Peach Bottom Atomic Power Station, Units 2 and 3
Renewed Facility Operating License Nos. DPR-44 and DPR-56
NRC Docket Nos. 50-277 and 50-278

Subject: License Amendment Request – Reactivity Anomalies Surveillance

Markup of Technical Specifications and Bases Pages

SR 3.1.2.1

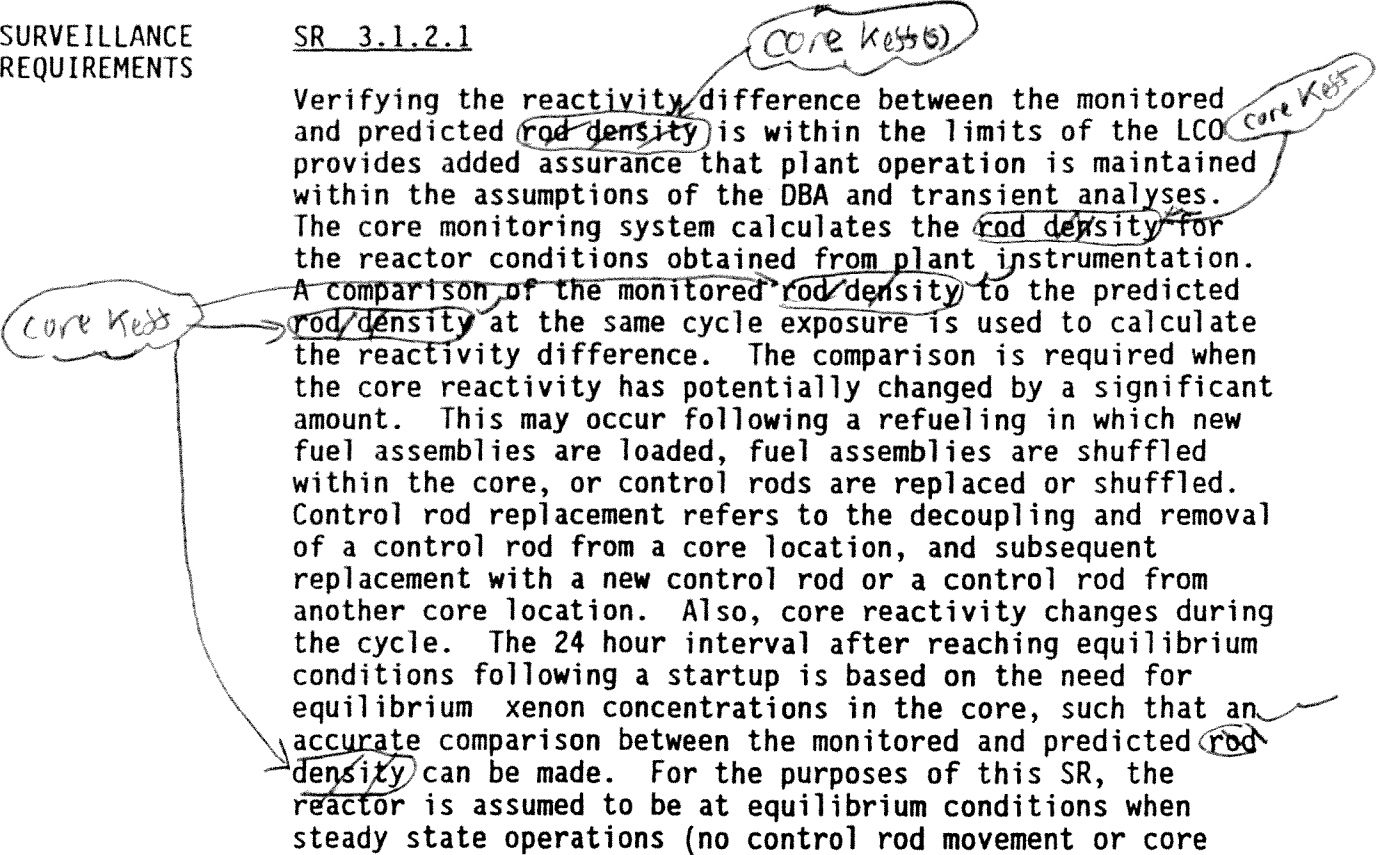
Verifying the reactivity difference between the monitored and predicted rod density is within the limits of the LCO provides added assurance that plant operation is maintained within the assumptions of the DBA and transient analyses. The core monitoring system calculates the rod density for the reactor conditions obtained from plant instrumentation. A comparison of the monitored rod density to the predicted rod density at the same cycle exposure is used to calculate the reactivity difference. The comparison is required when the core reactivity has potentially changed by a significant amount. This may occur following a refueling in which new fuel assemblies are loaded, fuel assemblies are shuffled within the core, or control rods are replaced or shuffled. Control rod replacement refers to the decoupling and removal of a control rod from a core location, and subsequent replacement with a new control rod or a control rod from another core location. Also, core reactivity changes during the cycle. The 24 hour interval after reaching equilibrium conditions following a startup is based on the need for equilibrium xenon concentrations in the core, such that an accurate comparison between the monitored and predicted rod density can be made. For the purposes of this SR, the reactor is assumed to be at equilibrium conditions when steady state operations (no control rod movement or core

SR 3.1.2.1

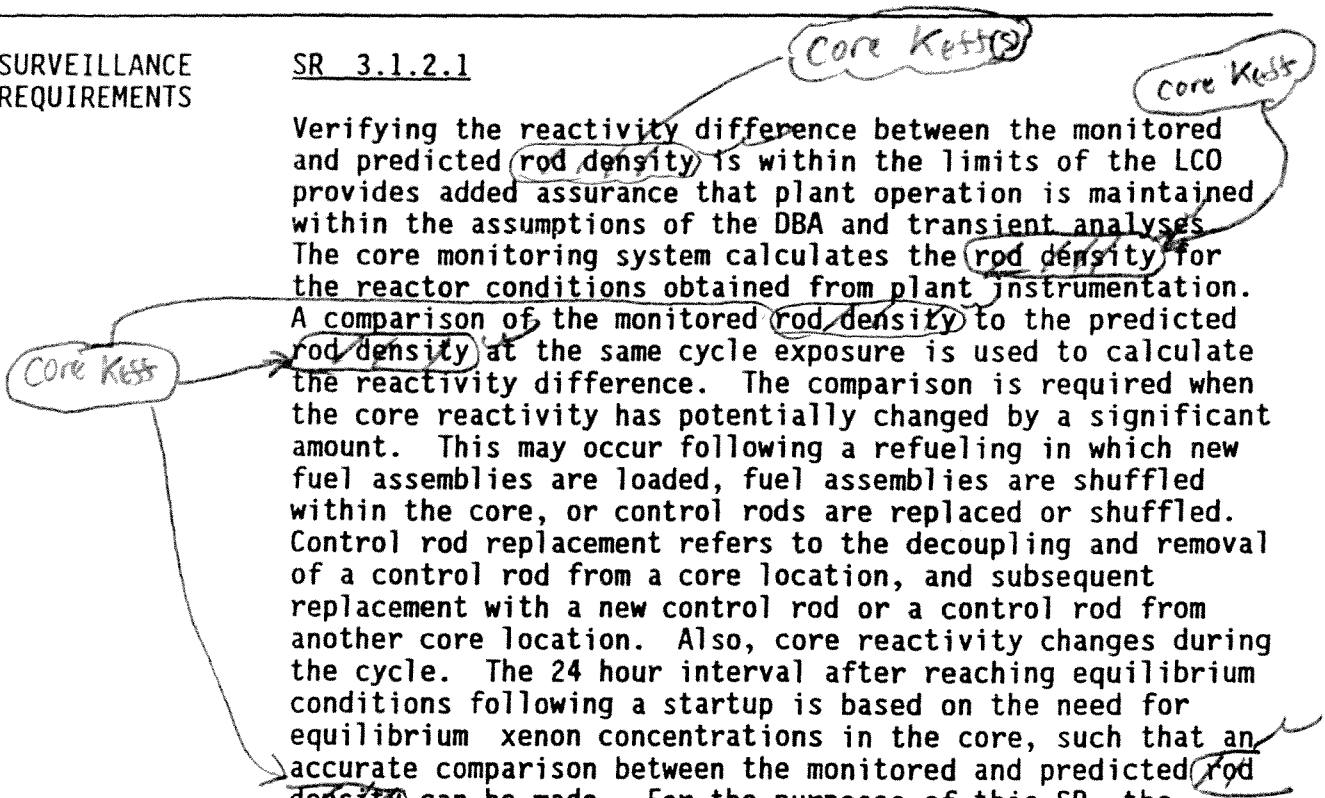
Verifying the reactivity difference between the monitored and predicted rod density is within the limits of the LCO provides added assurance that plant operation is maintained within the assumptions of the DBA and transient analyses. The core monitoring system calculates the rod density for the reactor conditions obtained from plant instrumentation. A comparison of the monitored rod density to the predicted rod density at the same cycle exposure is used to calculate the reactivity difference. The comparison is required when the core reactivity has potentially changed by a significant amount. This may occur following a refueling in which new fuel assemblies are loaded, fuel assemblies are shuffled within the core, or control rods are replaced or shuffled. Control rod replacement refers to the decoupling and removal of a control rod from a core location, and subsequent replacement with a new control rod or a control rod from another core location. Also, core reactivity changes during the cycle. The 24 hour interval after reaching equilibrium conditions following a startup is based on the need for equilibrium xenon concentrations in the core, such that an accurate comparison between the monitored and predicted rod density can be made. For the purposes of this SR, the reactor is assumed to be at equilibrium conditions when steady state operations (no control rod movement or core
